ERRATA TO THE TSB11C0A DATA SHEET

(TEXAS INSTRUMENTS LITERATURE NO. SLLS167A, MARCH 1996)

The following bulleted list contains corrections to the information contained in the TSB11C01 data sheet. This data sheet is also included in the Data Transmission Data Book, Volume 2, Communications Controllers beginning on page 4–3.

Figure 6. Status Transfer Timing

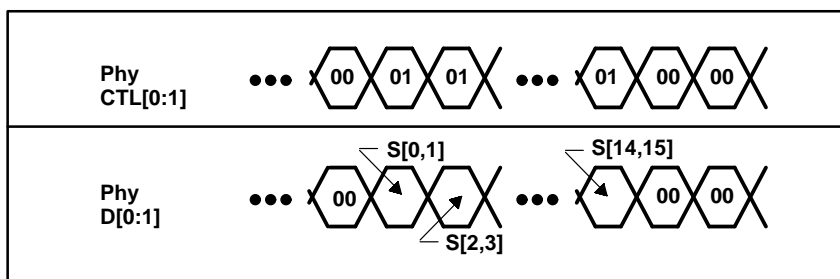
- The status transfer timing diagram in Figure 6 is in error. The following diagram is the correct version.
